Addendum 1

Project: **RFP NUMBER 2425-02 – TROY SCHOOL DISTRICT 2025 ROOF PROGRAM**

ADDENDUM NO.: <u>1</u>	DATE: <u>10/30/24</u>
PROJECT IDENTIFICATION	
PROJECT NAME:	BID NO. 2425-02 Troy School District 2025 Roof Program
SITE ADDRESS:	4400 Livernois Rd., Troy, MI 48098
ADDENDUM DESCRIPTION	
The following is a summary of changes to the Drawings and Specifications that shall be considered as a part of your Bid. Receipt of this Addendum shall be acknowledged in the Bid submission. This Addendum consists of 2 pages.	
SUMMARY OF ADDENDUM:

Baker Middle School
Roof Area B
Scale: 1/16" = 1'

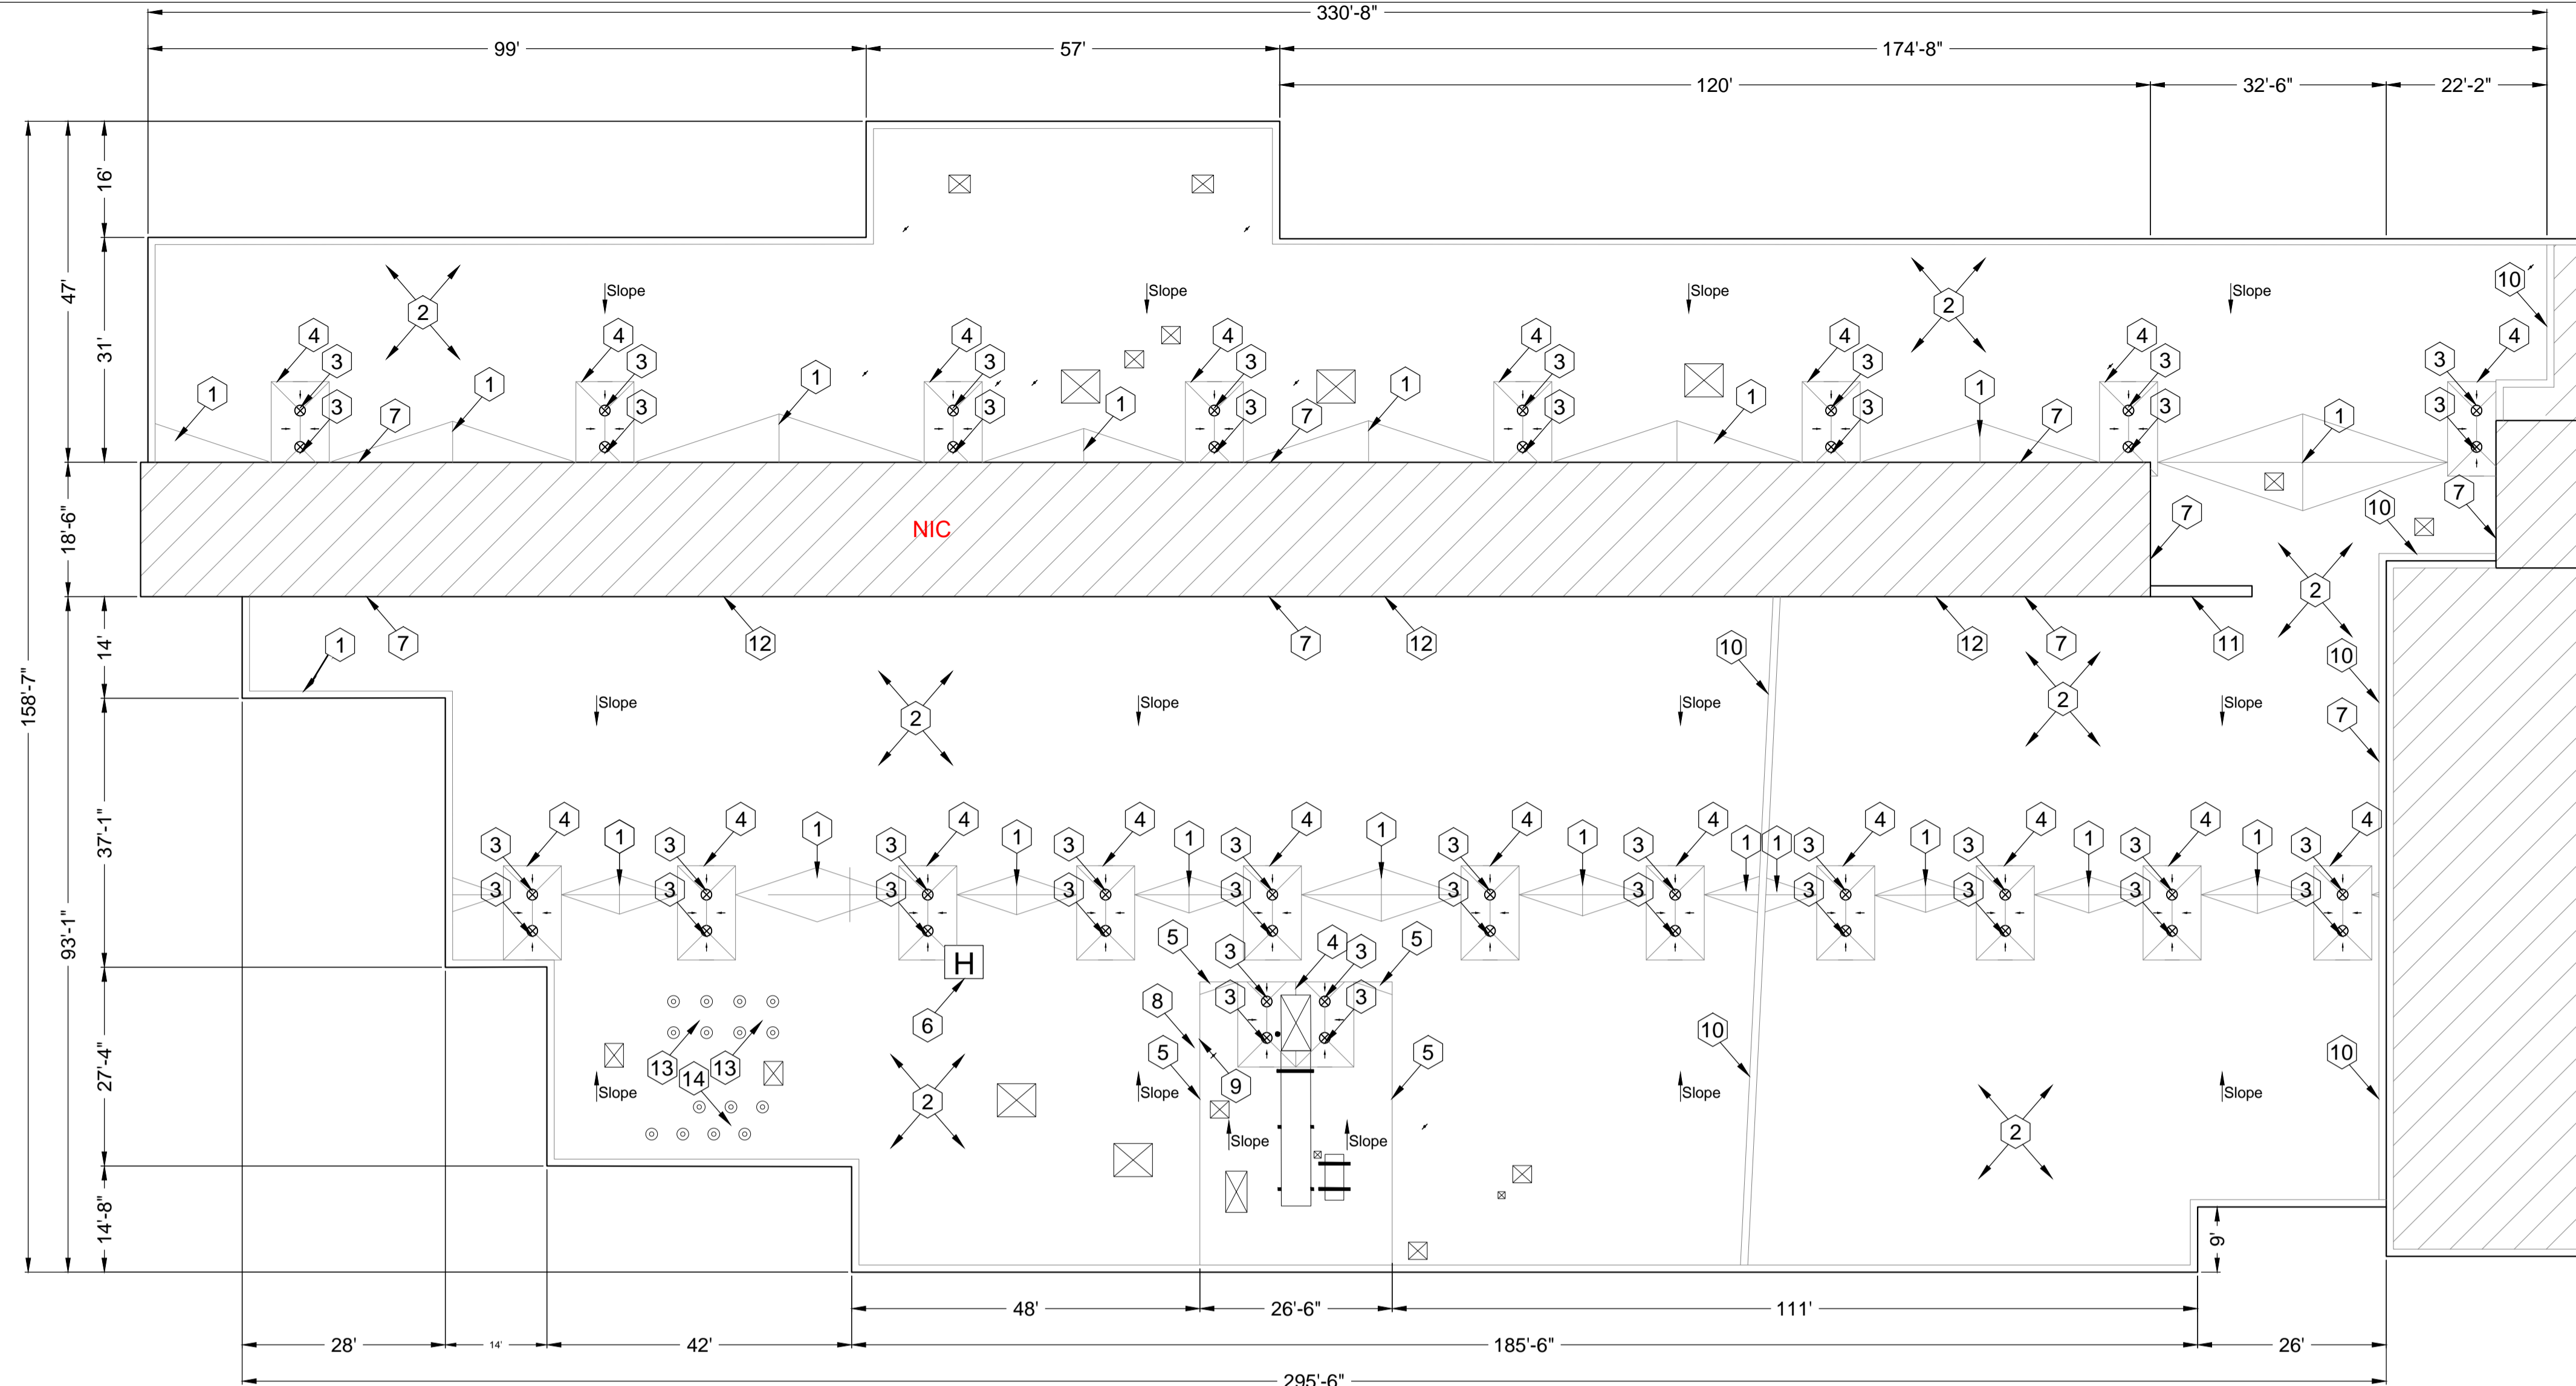
Item	Description
1.	Drawing A2.1 Roof Plan – Baker Middle School, Roof Area B (<i>Ref. A2.1 revised drawing</i>) CHANGE: Shingle roof is not included.
2.	Drawing A1.0 Cover Sheet (<i>Drawing will not be reissued</i>) ADDITION: Protection and Cleaning of Installed Roof Membrane: The roofing contractor is responsible for the protection of the newly installed sections roof membrane from scuffing, staining and discoloration. Protection of newly installed membrane may include, but are not limited to, use of roof membranes with manufacturer-applied protective film, full coverage of installed membrane with sealed tarps, sequencing of roof membrane installation in a manner to limit tear-off dust, dirt and debris migration, and limiting traffic on installed membrane. Upon completion of installation, scuffed, stained or discolored membrane shall be cleaned to the satisfaction of the owner and shall maintain the manufacturer-published initial solar reflectance of the product.

Troy Union Elementary School
Roof Area F
Scale: 1/16" = 1'

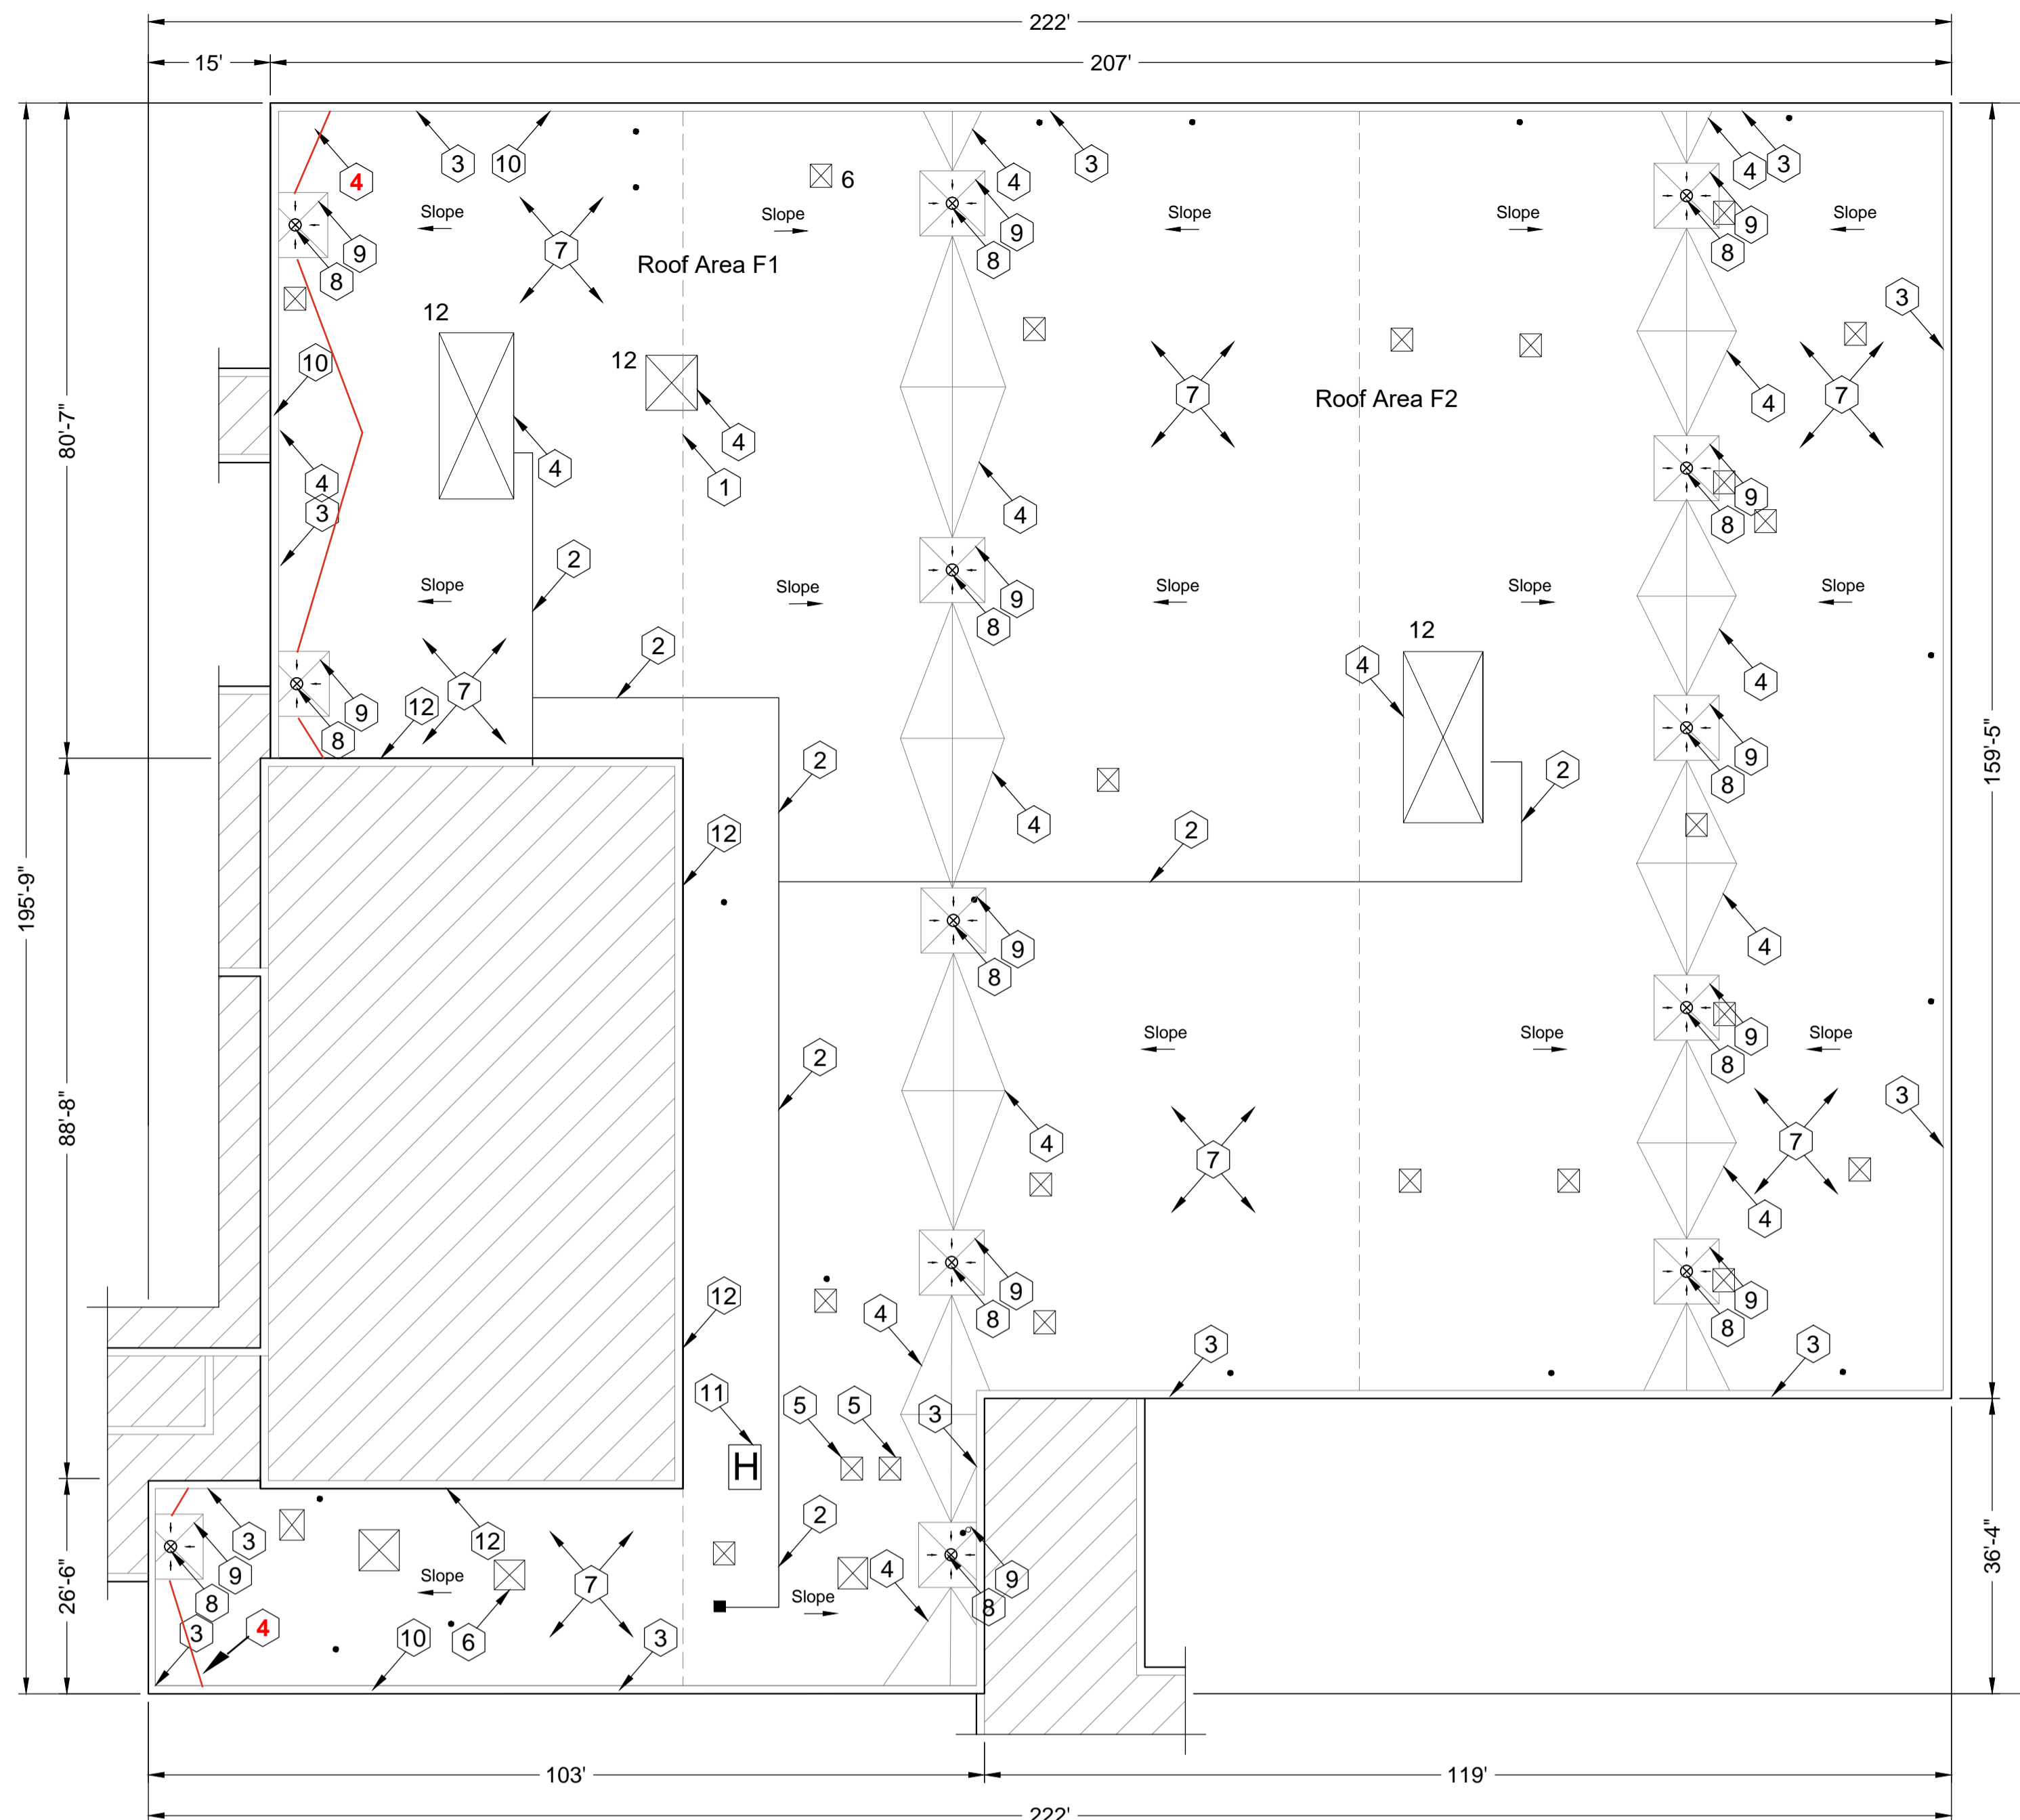
3.	Drawing A4.0 Roof Plan – Troy Union Elementary School, Roof Area F (<i>Ref. A4.0 revised drawing</i>) ADDITION: Refer to revised A4.0 drawing for additional tapered saddles as noted in Key Note 4 Saddle & Crickets.

1.09 ROOF DRAIN SUMP SCALE: N.T.S.

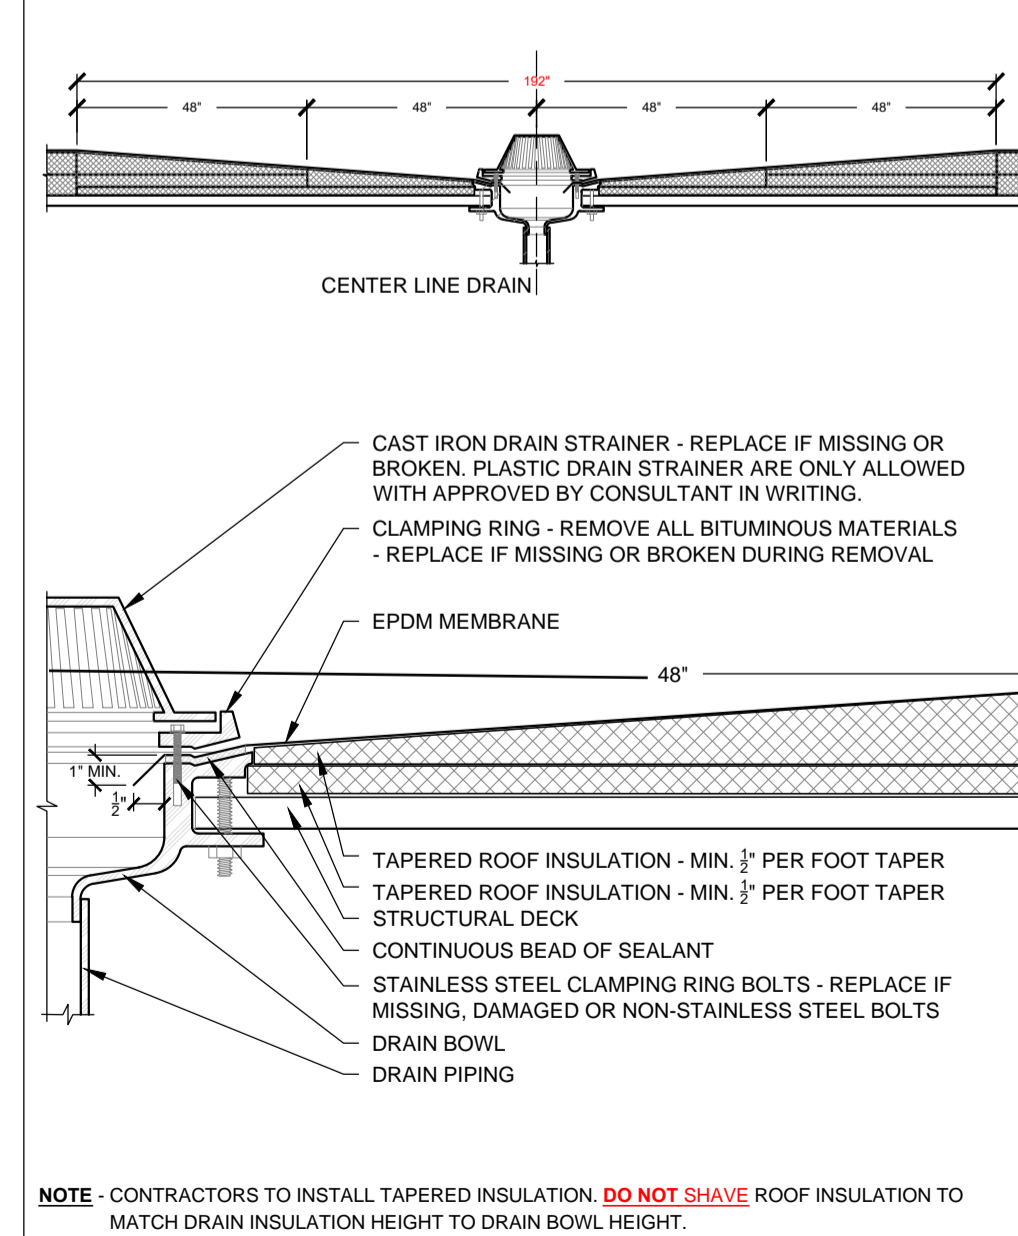
4.	Drawing A5.0 Detail Sheet (<i>Ref. A5.0 revised drawing</i>) CHANGE: Refer to revised A5.0 drawing for change to Details 1.09, 1.10, 1.11, 1.12.
5.	Ladder usage while students are in session: The roofing contractor should have a spotter at the bottom of the ladder, while working, when students are in session. (During non-summer work.)
